CONDITIONAL USE PLAN

LAND DEVELOPMENT FOR  
**THE MALVERN SCHOOL**

Re: Malvern School Conditional Use Plan  
Westtown Township  
EBWA No. 4432

### **McCormick Taylor Review Comments**

### CONDITIONAL USE LANDSCAPE PLAN

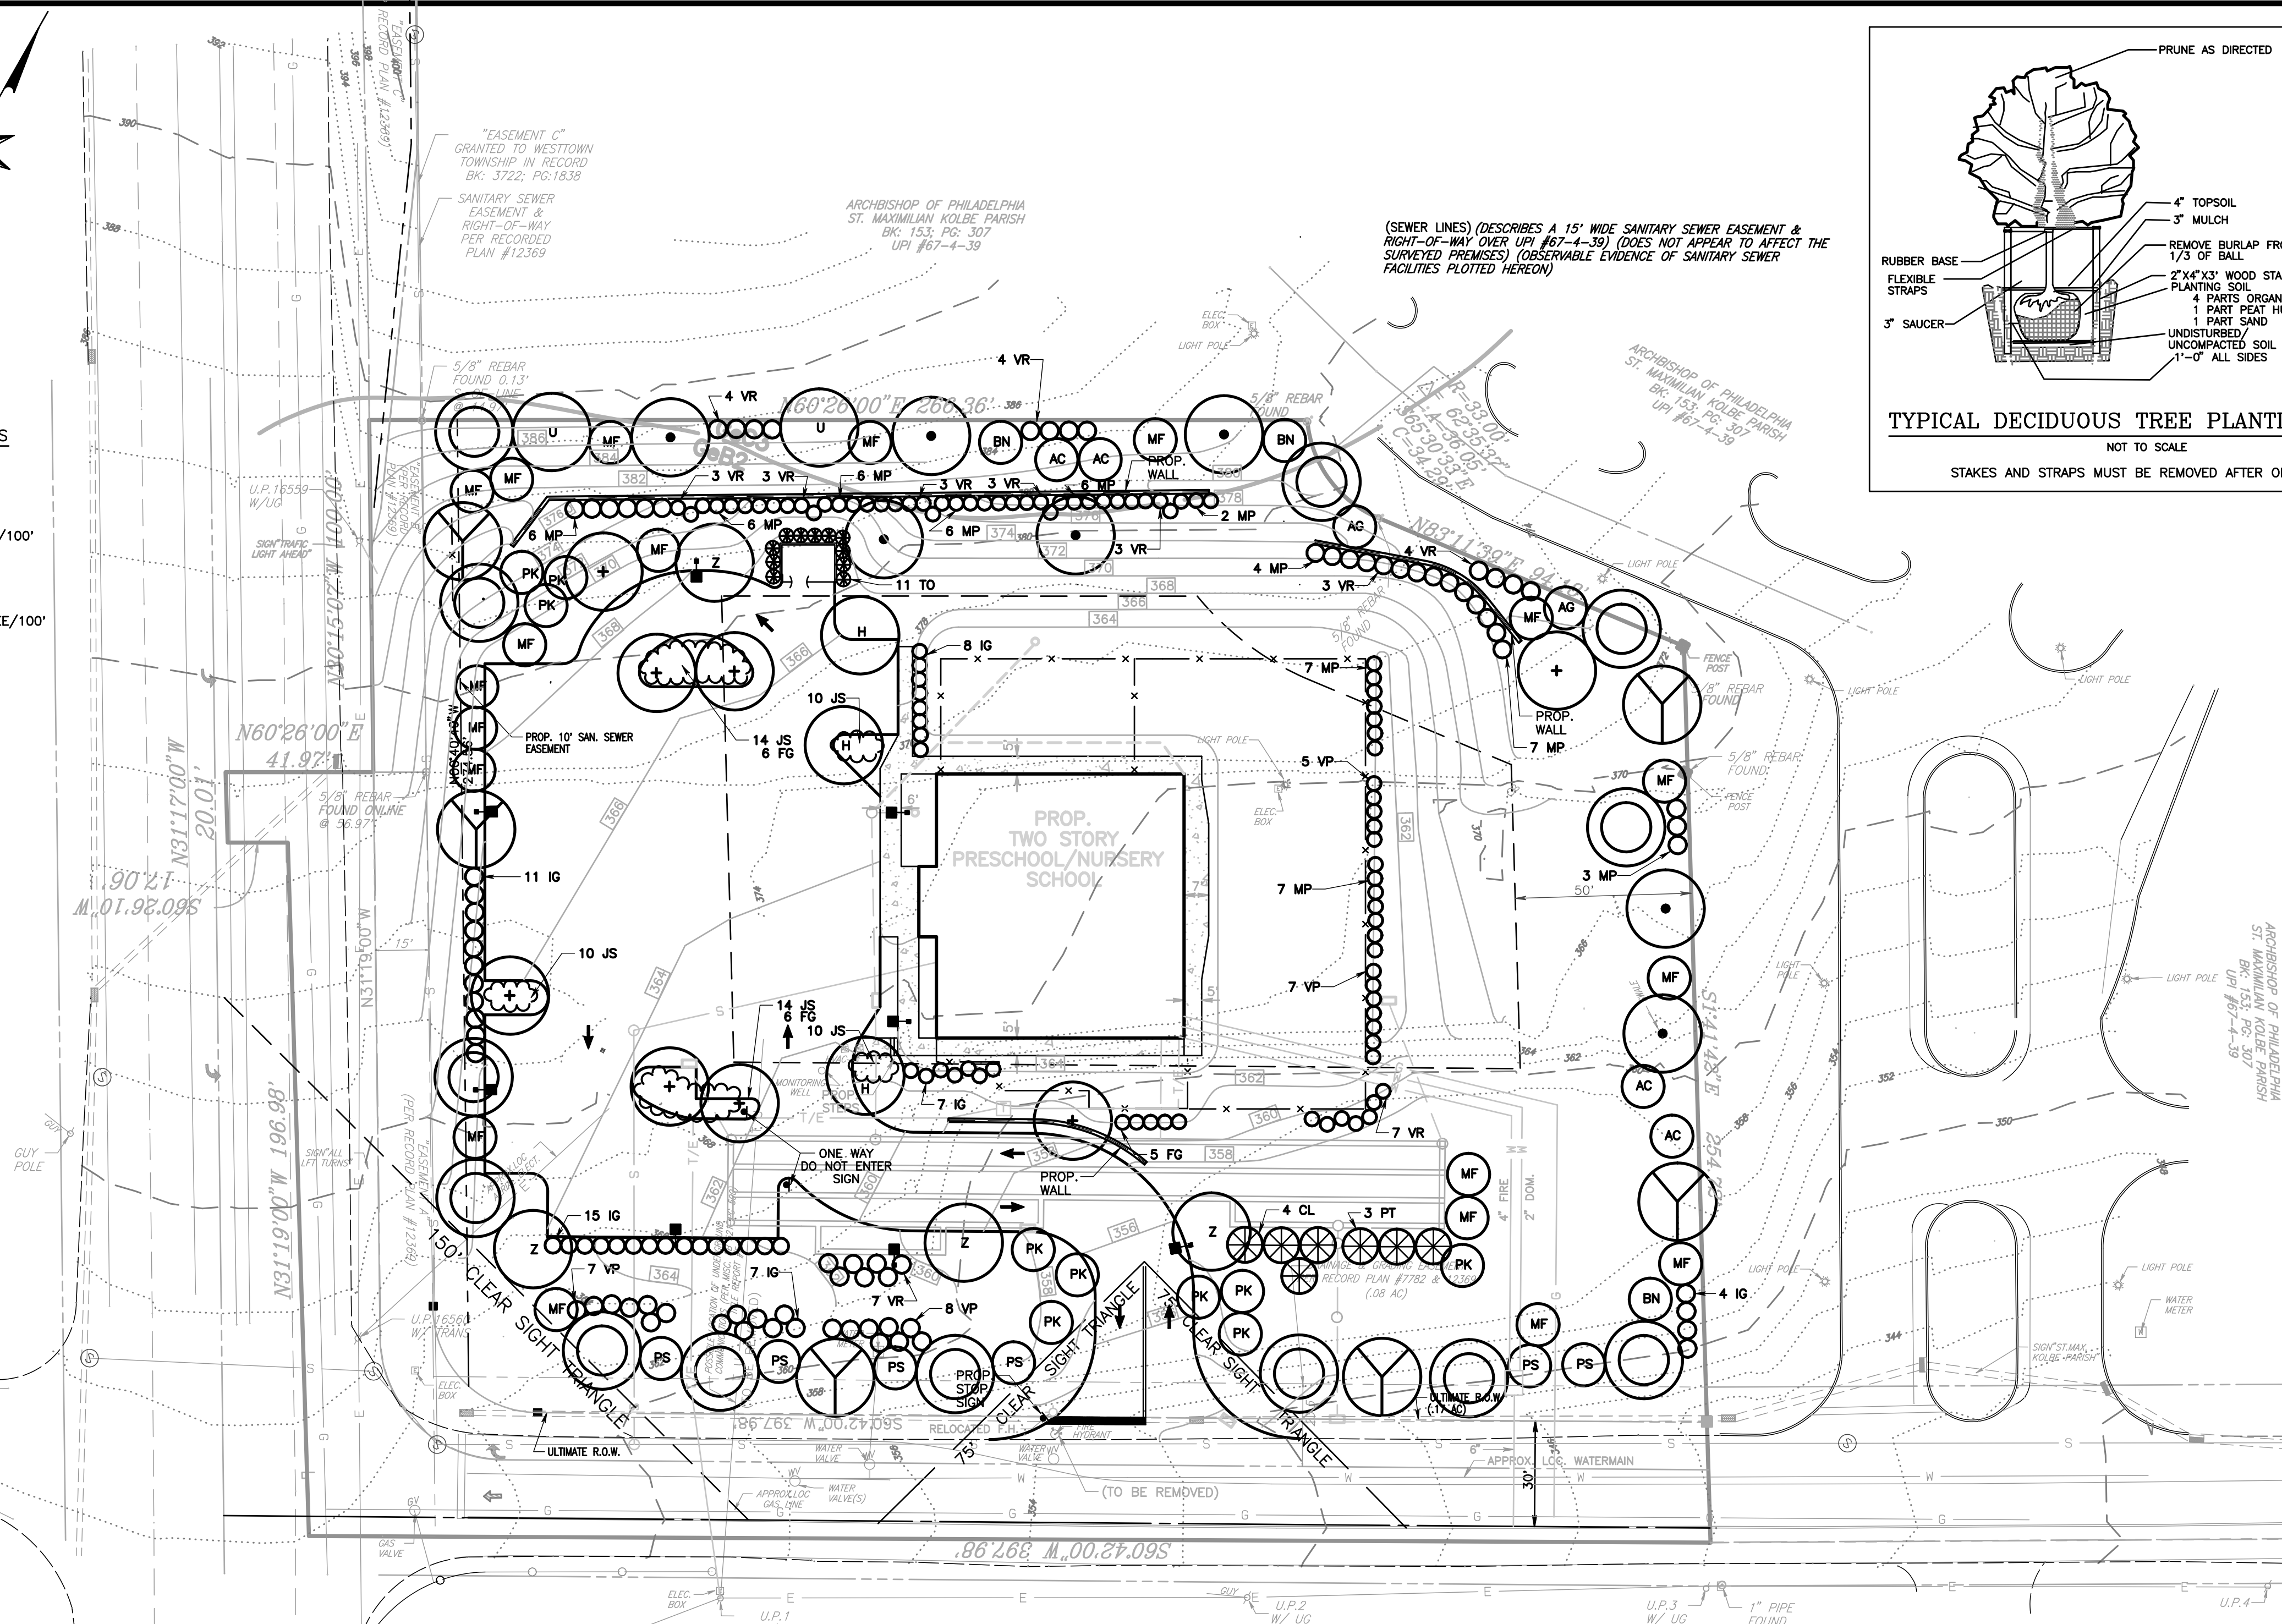
- A. A waiver request from Section 149-925.I.5 to allow landscape planting closer than 10' to a property of ROW line.

- 12vi. A waiver of the 10' foot setback has been requested.
- 12b. No vegetation will be planted within the ROW areas and the sign location note has been removed.

23. The trees have been shifted out of the sanitary sewer easement.
- 24-26 These items are to be addressed by the Malvern School during the Conditional Use Hearing and Land Development process.

### CONDITIONAL USE LIGHTING PLAN

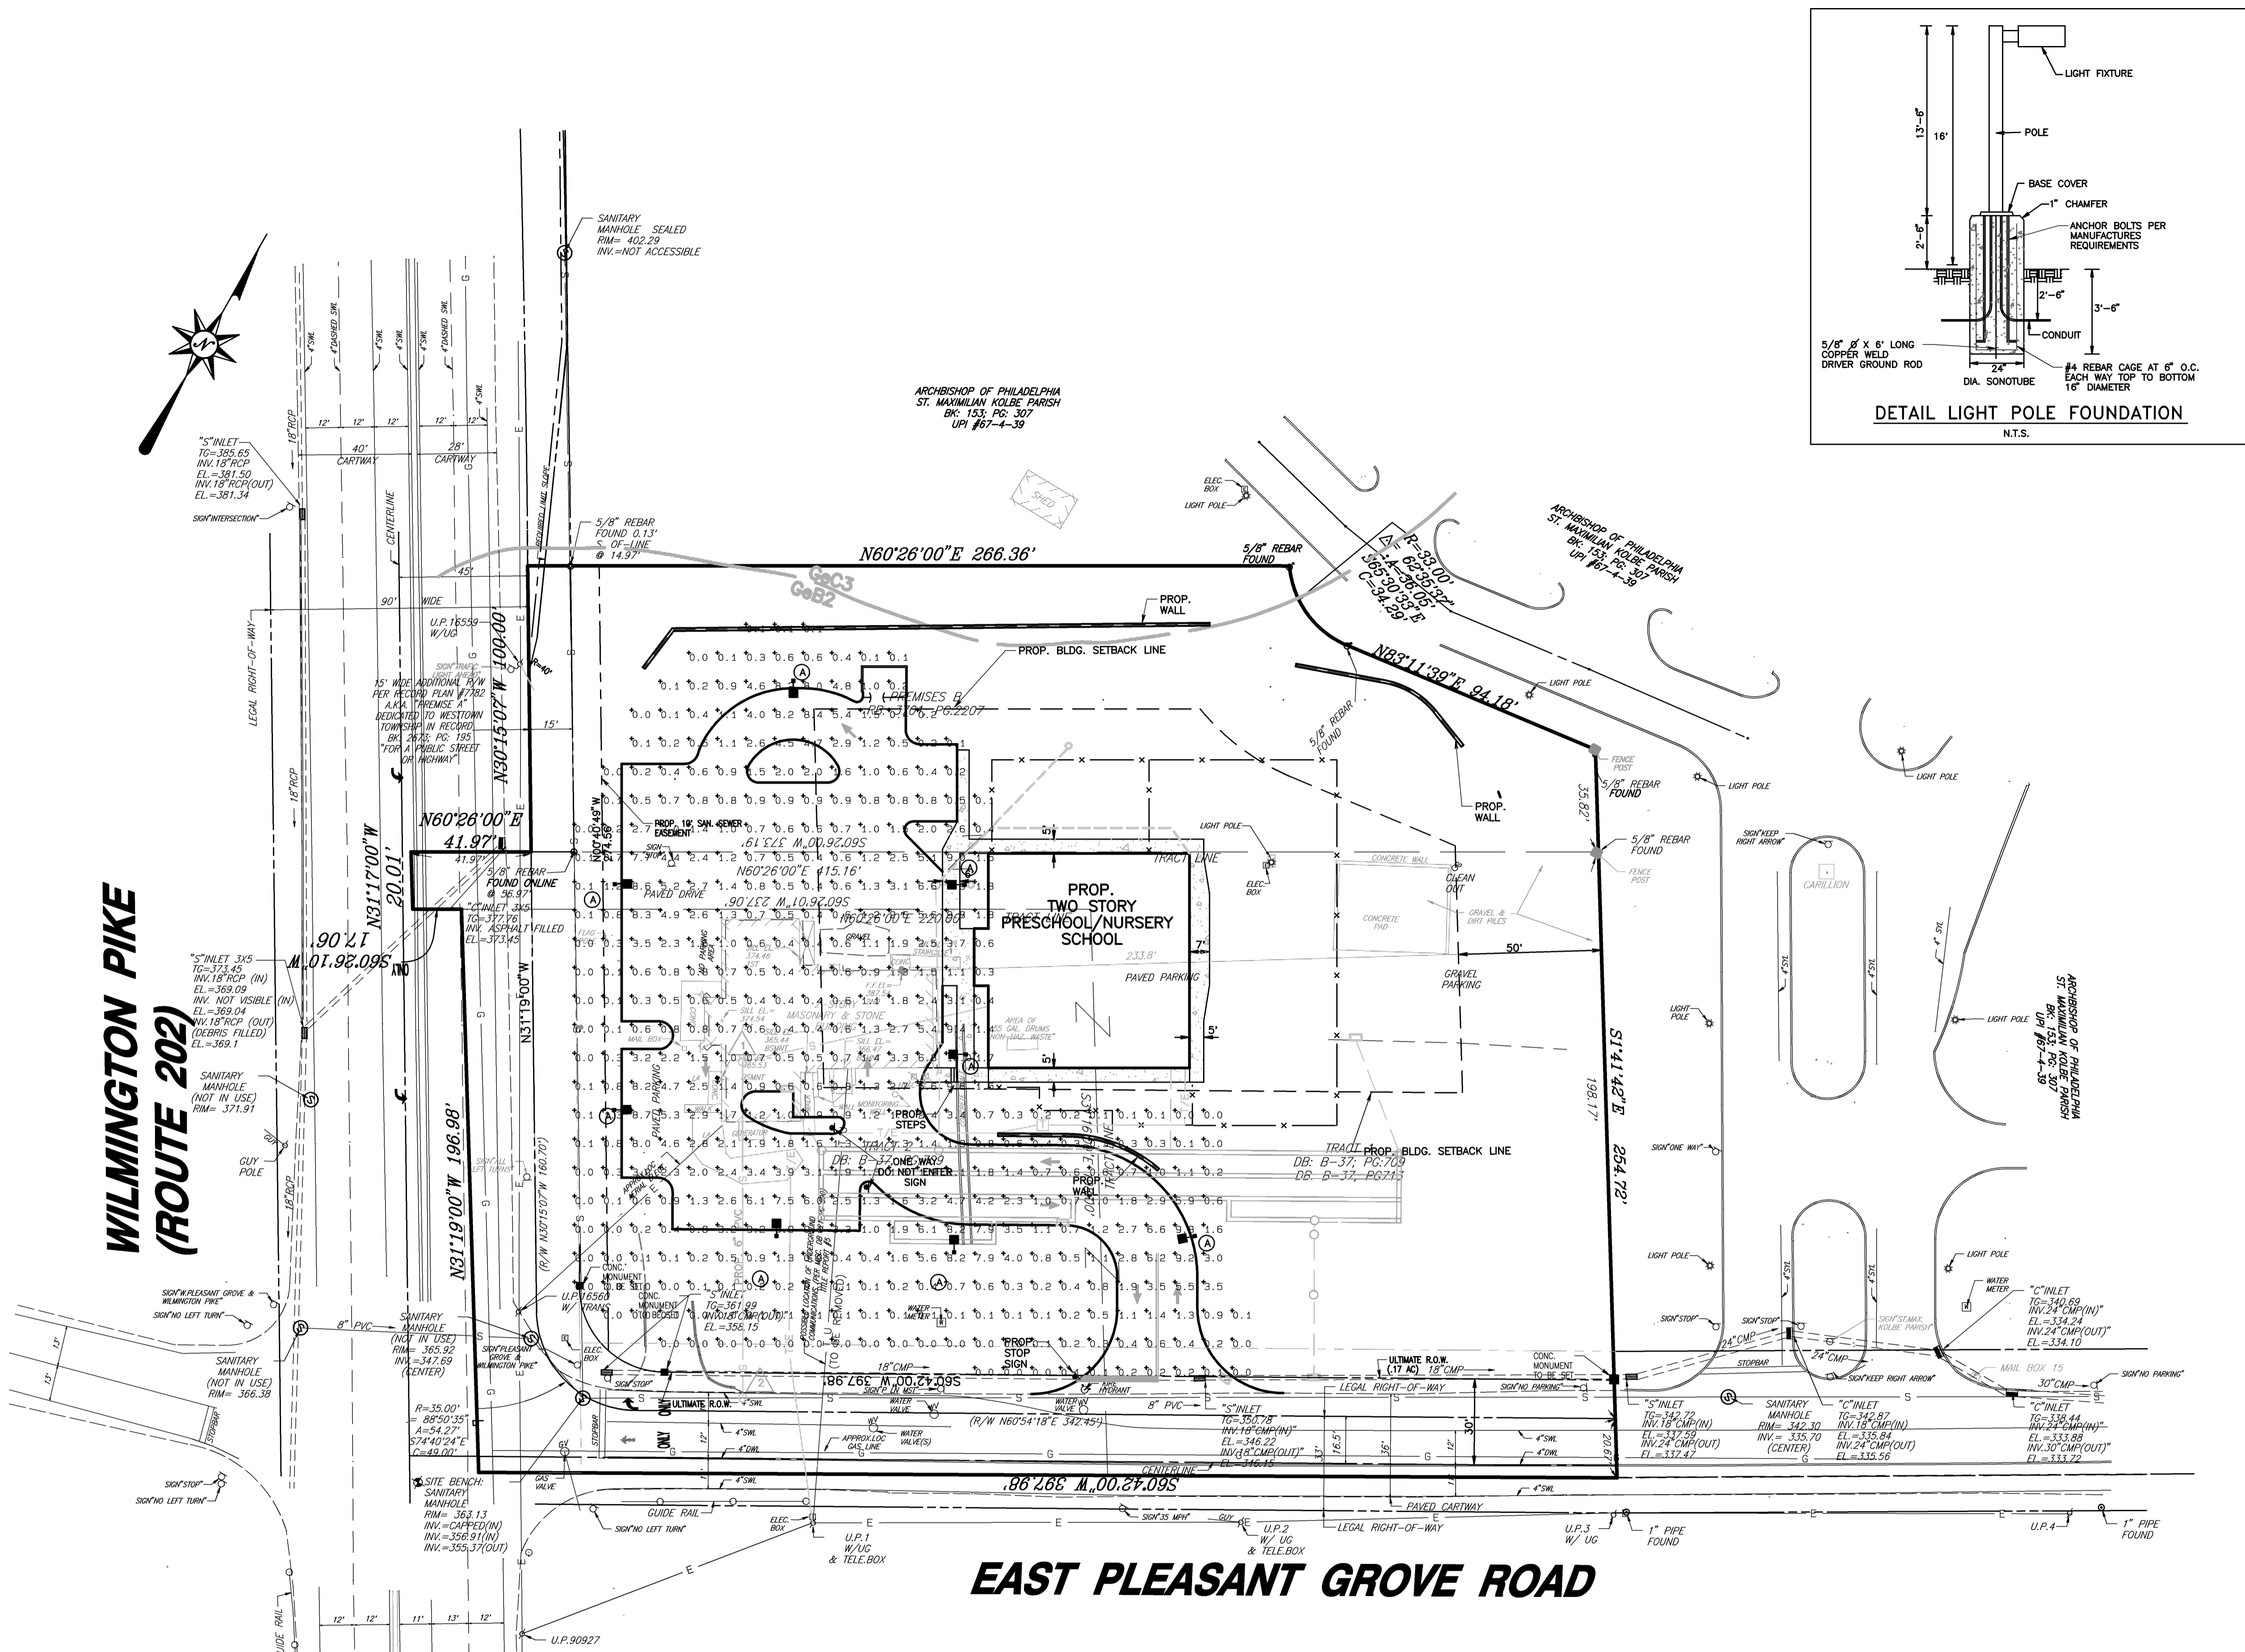
14. We have revised the lighting plan to meet the current ordinance provisions. All fixtures are cut off fixtures that direct the light down and reduce or eliminate glare.
